RE: Annual Inspection for Parcel BR (part of)

North Ridge Estates Superfund Site

ECSI No. 6018

# Operations and Maintenance Inspection Form

Parcel BR

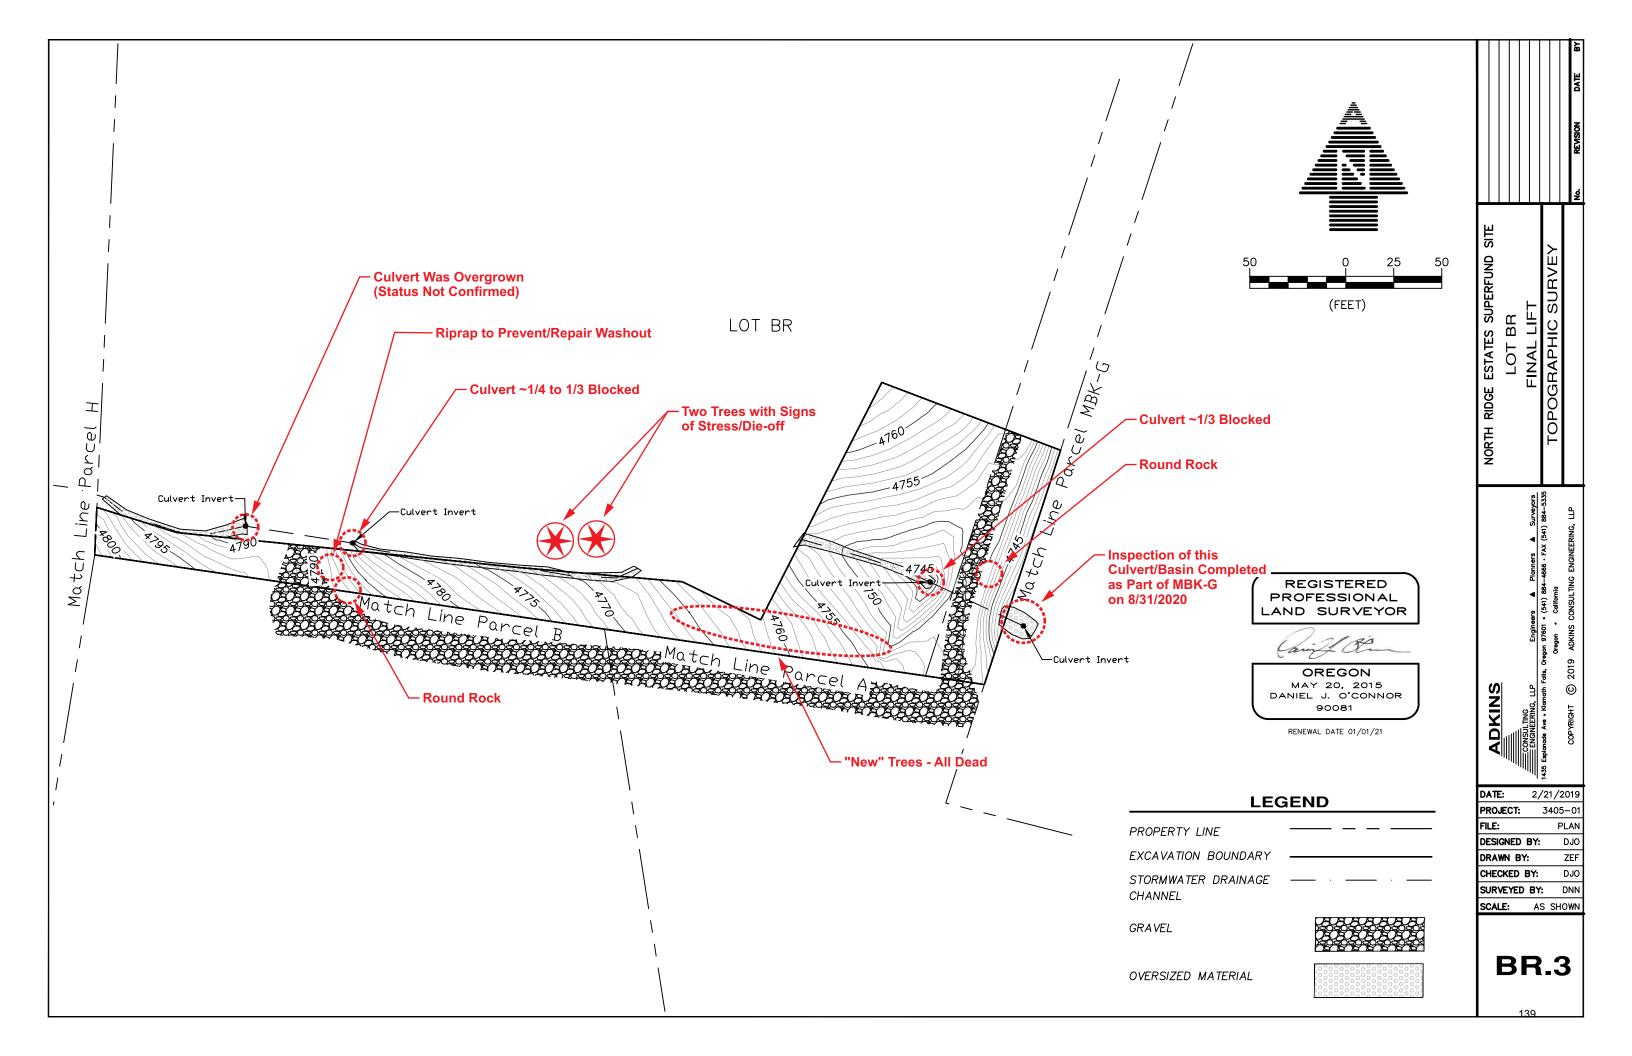
Are there areas that show evidence of unstable slopes, subsidence, or slope failure? Are there signs of active bank erosion and/or lateral cutting?			×						
	Any visible ACM along the perimeter of the Site (where applicable)?			×						
Vegetation	Evidence of distressed or sparse vegetation? (sparse vegetation no greater than 10 percent of area and bare areas no greater than 100 square feet)			×						
	Evidence of trees and shrubs in distress?		×			Yes. Many of t	the newly planted trees are showing signs of stre are showing sig	ss and two legacy trees just to the north of the removal are uns of die off.	a	
	Are there any stressed or dying trees that may impact or damage the protective when felled?			×			Two legacy trees (mentioned above) are no	ot believe to be able to damage the cap.

Ditches and Culverts	Obstructions observed in ditches or culverts that may impede conveyance of stormwater?	×			All onsite culverts has some level of blockage (~1/4 to 1/3), but may not significantly impact drainage.	Culverts could be cleared.
	Damaged observed to riprap surface? Note if riprap is not intact or not effectively providing armor protection.		X			
	Are there any areas that show signs of excessive scour? (i.e., gullies forming along centerline of ditch)		×		There are two or more locations where rock has been added to prevent stormwater scour as it enters the drainage ditch	
	Are culvert inlets and outlets damaged?		×			
Driveways and Walkways	Are the driveways showing signs are failure? (i.e., alligator cracking)			×	Driving surfaces were gravel.	
	Are there any other signs of considerable damage to paved surfaces, other than normal wear and use?			×		
Crawlspaces and Decks	Are the liners inside crawlspaces and under covered decks damaged or punctured?			×

Several of the newly planted trees are dying or stressed.

Some of the culverts were heavily overgrown.

At least one of the culverts at the BR removal area was substantially blocked by sediment.

Two legacy trees just north of the cap were stressed/dying. If felled, it is unlikely to damage the cap.
